ROSEVILLE
REQUEST FOR COUNCIL ACTION

Date: 10/11/2010

Item Description: Request by United Properties for approval of a PLAT to allow the proposed senior cooperative residence at 3008-3010 Cleveland Avenue to be developed in 2 phases, consistent with the development approval (PF07-006)

PRELIMINARY PLAT

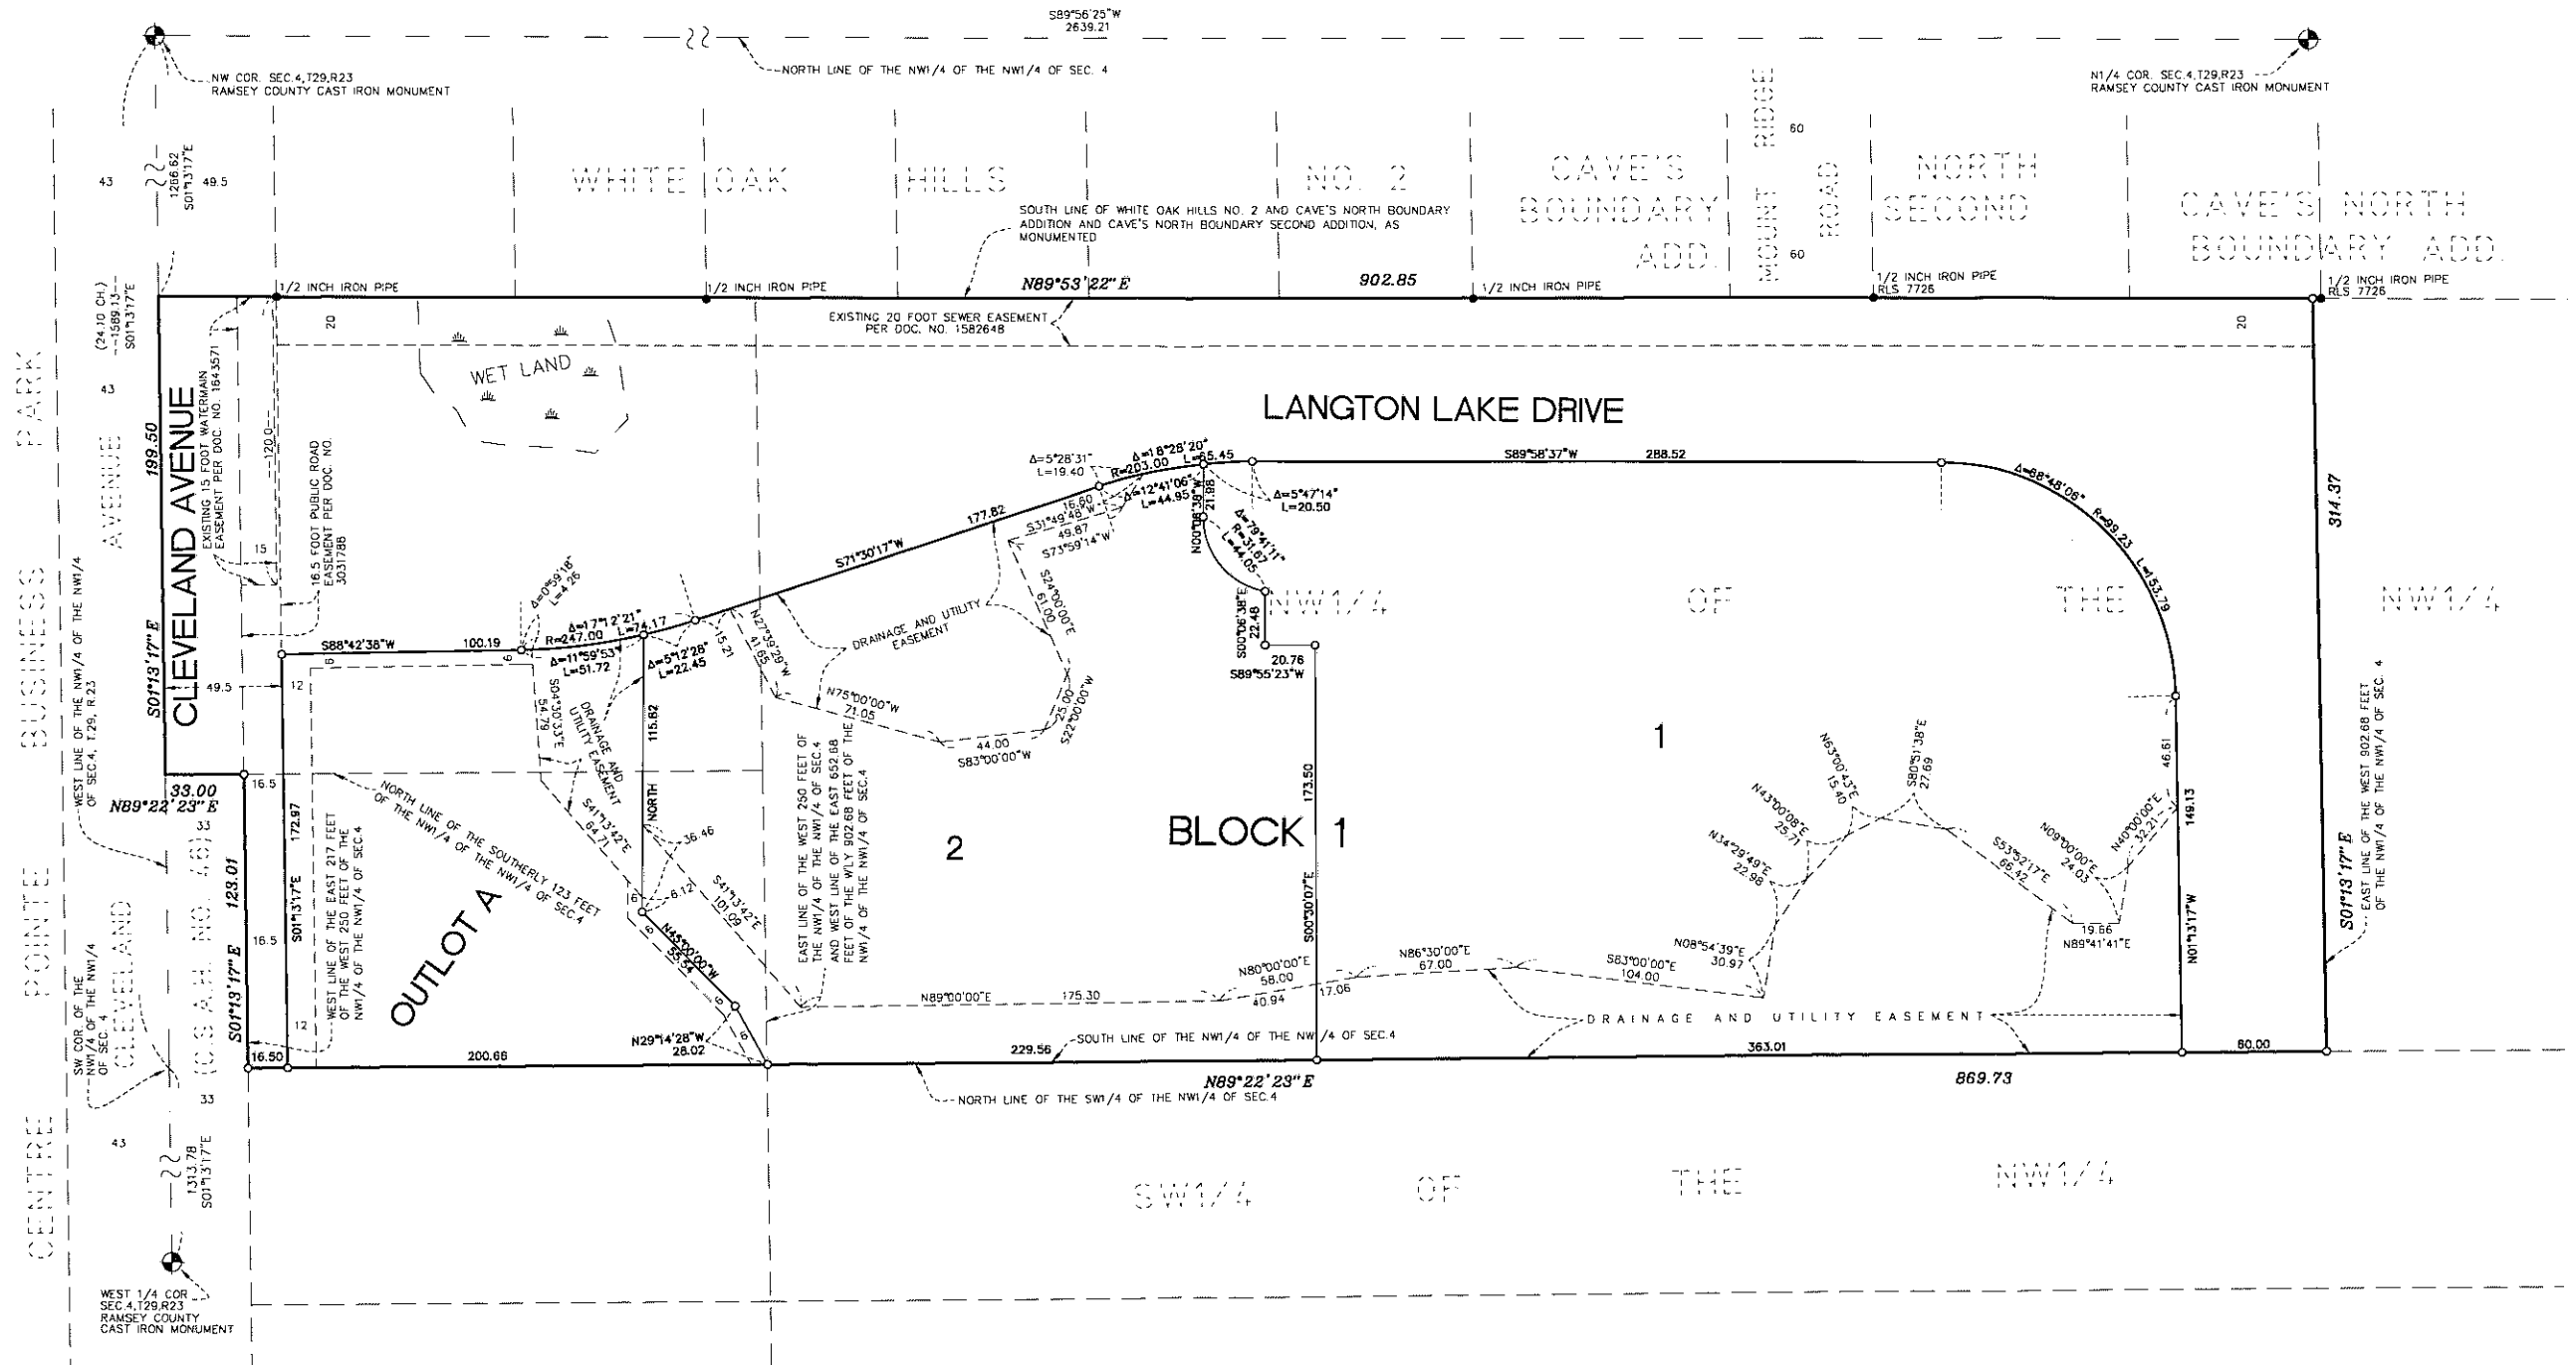
43 5.1 The present PLAT application does not represent any proposed changes to the approved
44 cooperative residential development or the approved size and layout of the new public
45 road. The only proposed change is to divide the lot for the cooperative residence into two
46 lots: an eastern lot (i.e., Lot 1) for the construction of Phase I and a western lot (i.e., Lot
47 2) for the future Phase II. In fact, if the second phase of the cooperative residential
48 development never comes about, the approved PUD wouldn't allow any development on
49 Lot 2 without a formal amendment of the development agreement. As noted above, the
50 only purpose for this new lot line is to enable the completed Phase I property to be owned
51 by the cooperative while Lot 2 is retained by United Properties for the potential
52 development of Phase II as approved in the 2009 PUD amendment. If the current PLAT
53 application is approved, it will supersede the previous PLAT approvals.

54 5.2 For the sake of clarification, the nature of an "outlot" is such that it may not be developed
55 until it is re-platted. In this case, the intent is to include the proposed Outlot A on a plat
56 with the other properties to be used for the proposed assisted living facility, consistent
57 with the General Concept approval already granted for that project.

- 62 **a.** Building Code requirements typically mandate certain property line setbacks, but
63 heightened construction standards and/or covenants to restrict and define the
64 developments on the two lots can resolve potential conflict with the Building
65 Code created by the proposed zero-foot setbacks from the interior lot line; and
- 66 **b.** United Properties will need to be sure that neither Phase I nor Phase II will create
67 dead-end corridors within the structure;

75 Based on the information and comments in Sections 4-6 of this report, Planning Division
76 staff recommends approval of proposed PLAT of the property at 3008-3010 Cleveland
77 Avenue, subject to the condition that an approved new plat shall supersede the previous
78 approvals by the Roseville City Council on September 15, 2008 and August 17, 2009,
79 thus the applicant shall provide letter in advance of the October 11, 2010 City Council
80 meeting acknowledging that approval of the new plat nullifies the previous plat
81 approvals.

C-3.01

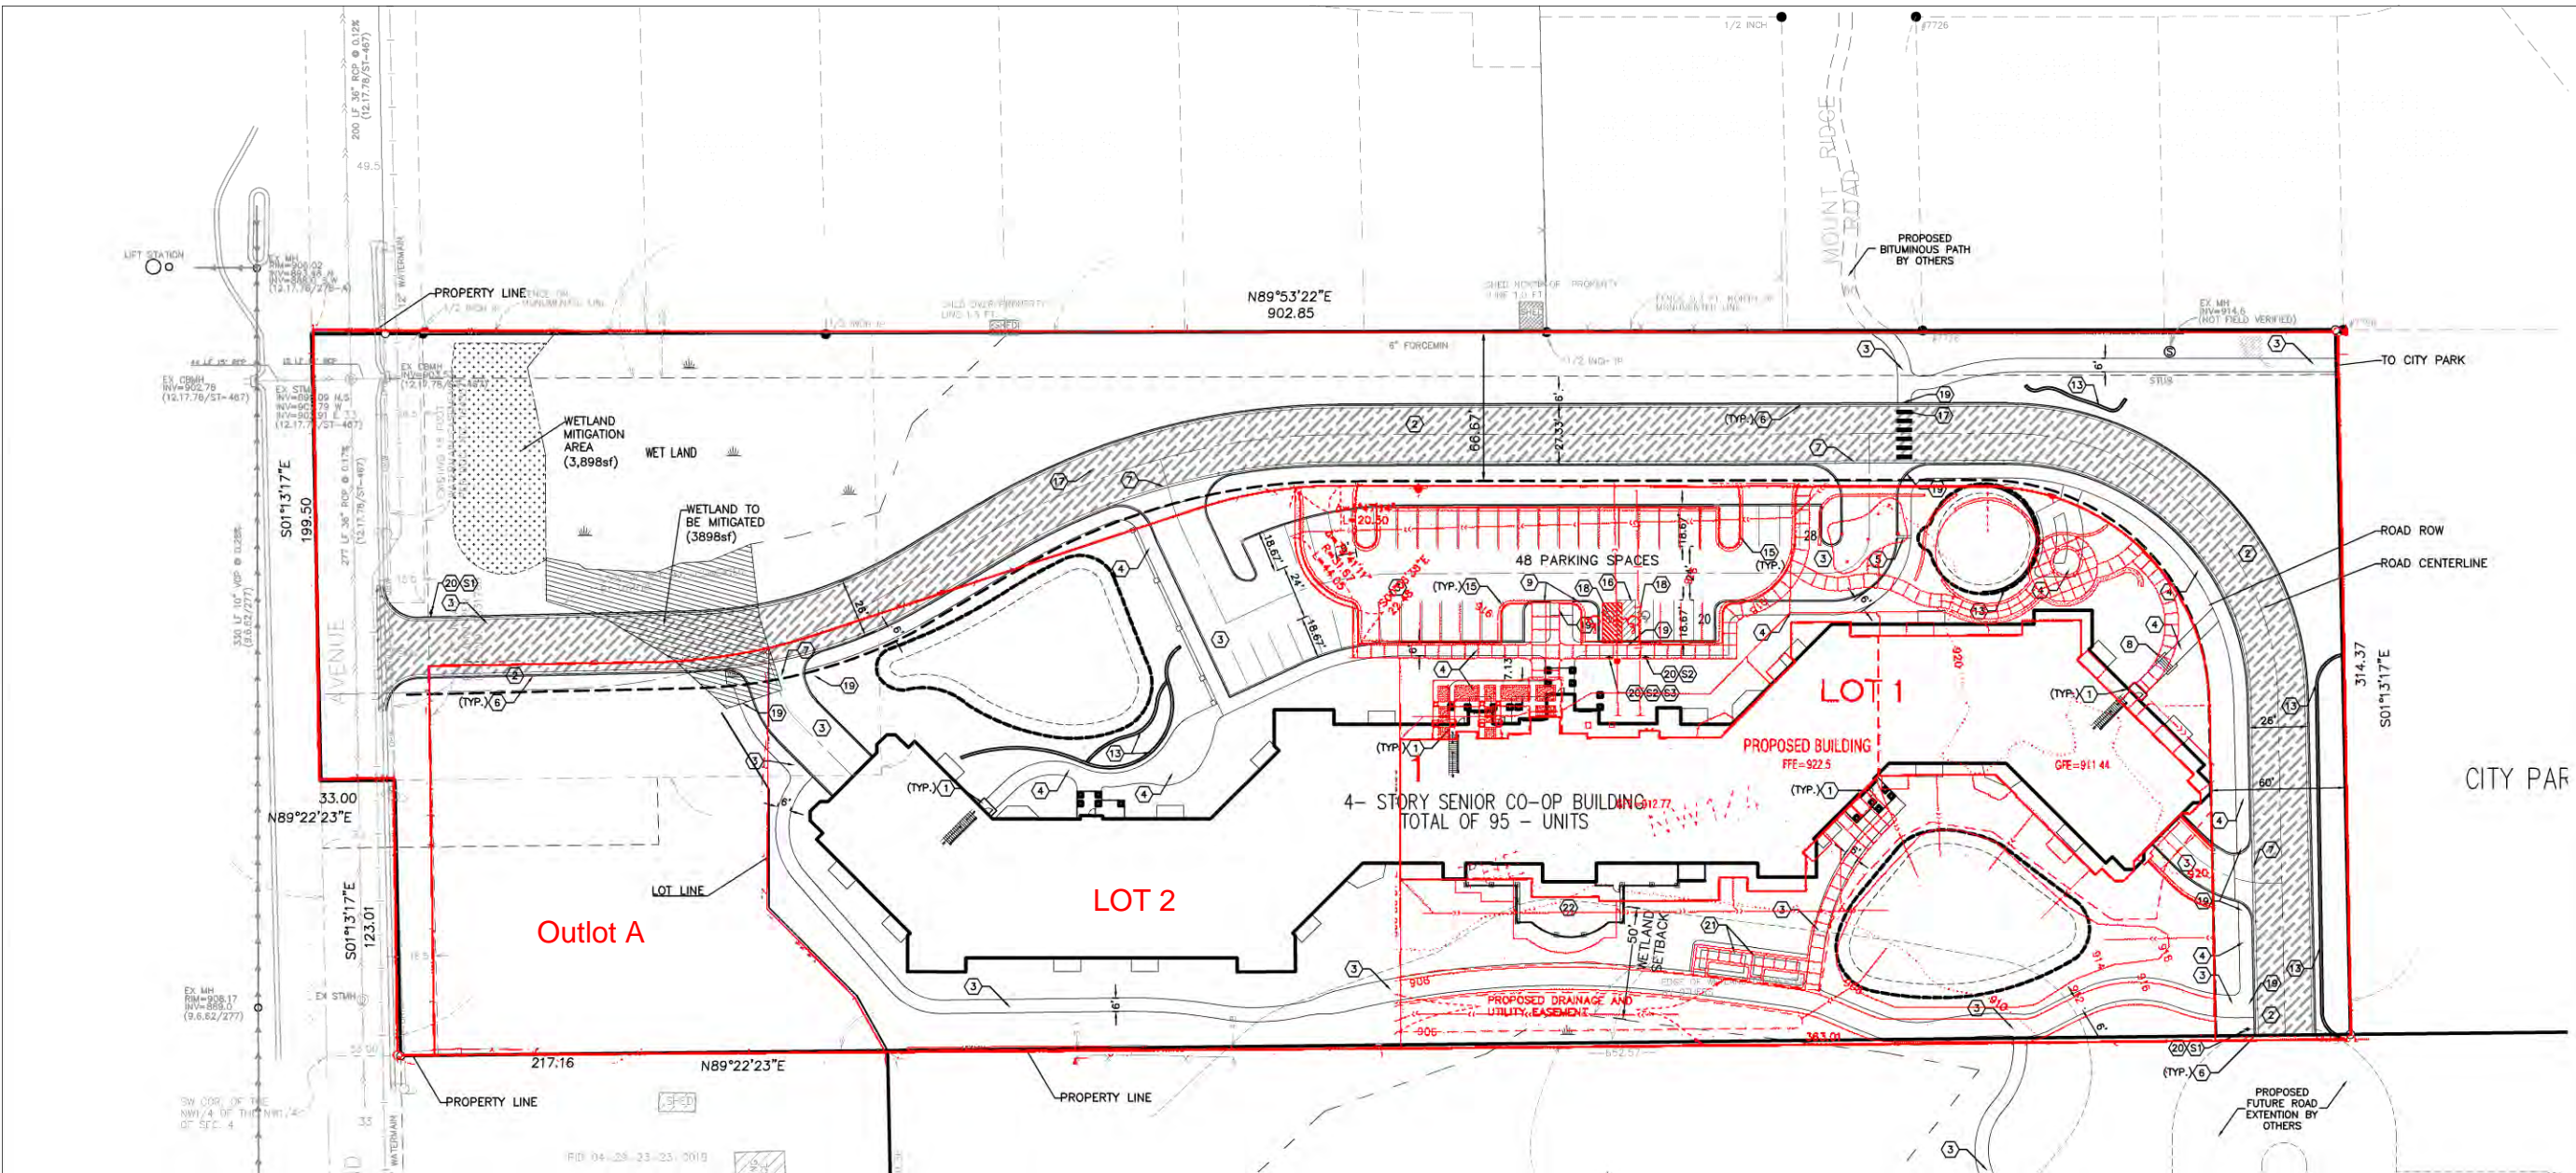
The base sheet (i.e., C-3.01), in black ink, is the approved PUD site plan. The red ink overlay represents the proposed plat with a development sketch of Lot 1.

The purpose of this illustration is to show that the proposed plat can accommodate development that is substantially consistent with the approved PUD.
